Subject: FW: Lido Apartments

We were informed at a Copper Ranch Board of Directors meeting held Thursday April 27th that there is new discussion going on between Lido Equities and the City regarding the privacy concerns between Lido Apartments and Copper Ranch. The developer stated he wants to eliminate the walkway between the two properties and add additional landscaping along the property line. This will help to maintain privacy for The Copper Ranch owners who are the most affected by the size and scope of the Lido Apartments. It was also stated that screening will be provided to shield headlights that will shine directly into those Copper Ranch units. Woodside Blvd very conveniently connects the Lido apartments to the Gravity Fitness Center; apartment residents can easily use Woodside for gym access.. There is no need for these residents to "cut through" Copper Ranch property. It is an invasion of privacy and security. The residents of Copper Ranch are in total support of the Developers plan to move forward with this. I respectfully request the Commissioners approve this important improvement for the health, safety and welfare of Copper Ranch residents.

RE: Design Review Appli

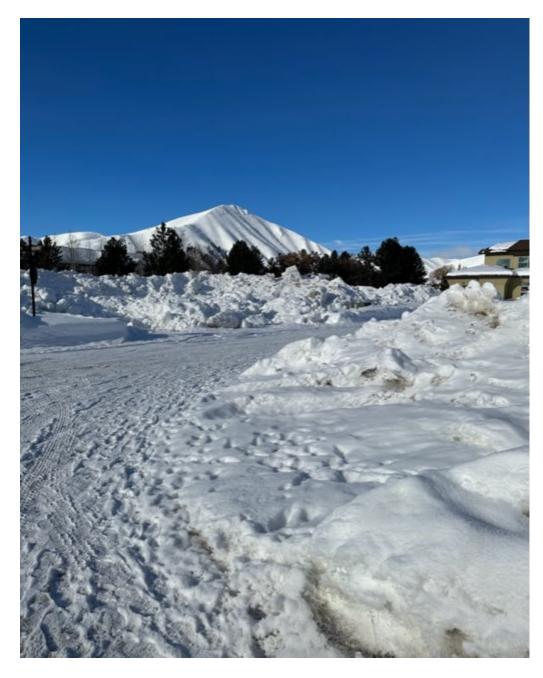
Regarding parking. I have concerns about the number of parking spaces. Including garage parking in the total number of parking spaces is not a good plan. The majority of current residents do not park in their garages. Most it seems are used for storage of garbage cans, bicycles, tools, extra furniture, Christmas decorations bulk storage etc. Also large vehicles will not fit in the single car garages. In addition one of the units will be located in what has become a makeshift parking lot. Most of the time there's at least 8-10 vehicles parked there overnight. We also have curbside parking at the end of Copper Ranch Lane adjacent to Lido's new apartment development. I believe this is a fire lane.

My second concern is for proper snow storage. The area currently being used is on both sides of Wimpleton Court. There will be new units built in this area. I would ask that enough area be set aside for easy access for snow removal equipment and away from parking areas. I currently have a mound of snow outside my front door in a parking place, as does my

neighbor across the way. This occurs every year regardless of the of snowfall. Two parking spaces are lost for most of the winter.

1 Curbside parking Copper Ranch Lane on a Sunday morning.

2 Makeshift parking. Taken at 10am on a weekday. Lot usually contains at least 8 to 10 cars overnight.

$\mbox{\tt\#\,3\,Some}$ of the snow storage used this year. This is off Wimpleton Court.
